SERVICE BULLETIN

No. 546

Piper Aircraft Corporation

Subject: Inspection of Whelen Wing Tip Strobe Lights; Reference F.A.A. Airworthiness Directive 75-05-04

WHELEN NAVIGATION AND STROBE LIGHT ASSEMBLY

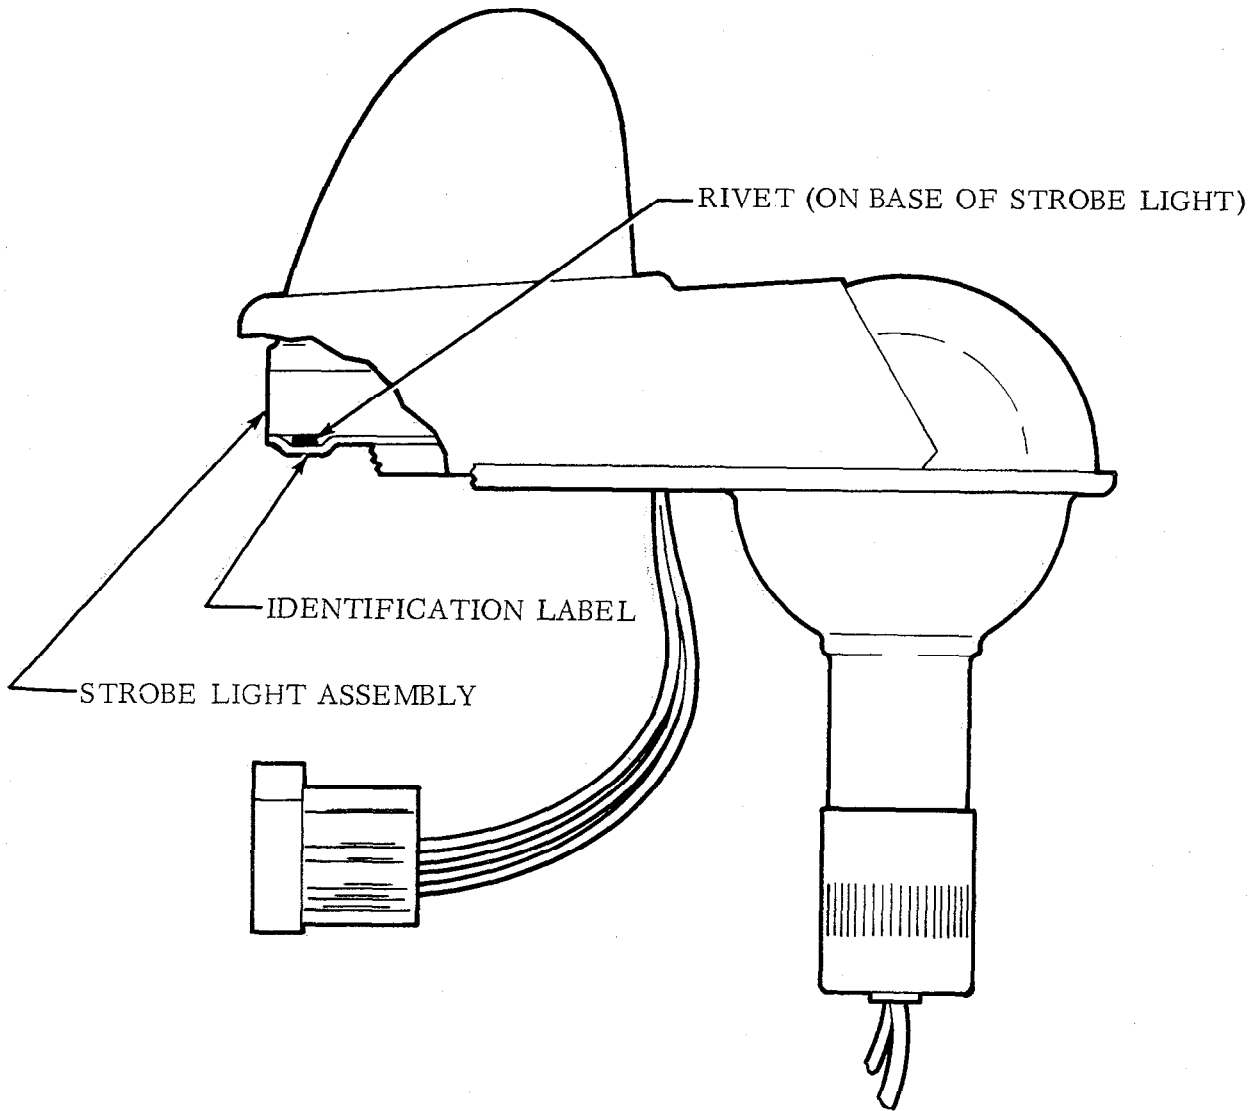
1. Expose wing tip strobe light assembly to view (refer to attached sketch for a typical strobe light assembly illustrated view).
2. If the following modification has already been accomplished, no further action is required; make appropriate entry in aircraft log book re compliance with this Service Release.

3. If the following modification has not been accomplished, proceed as follows:
 - a. Install on the base of the Whelen A-427 Flash Tube Assembly a pressure sensitive vinyl label conforming to Whelen drawing no. A-30052, Revision 1 dated October 15, 1974 or later F.A.A. approved revision.

1. Scotch Brand Type 33+ Vinyl Plastic electrical tape or equivalent tape - approved by an F.A.A. Maintenance/Avionics Inspector may be used in lieu of the vinyl label (if any plastic tape is used, it must be formed to cover the rivet at the rear of the flash tube without covering the identifying part number).

3. b. If the flash tube incorporates a label, the new label or tape may be installed directly over the old label.
- c. Install label or tape only when the label or tape and the flash tube are at a temperature above 50 degrees F.
4. Make appropriate service release compliance entry in aircraft log book.
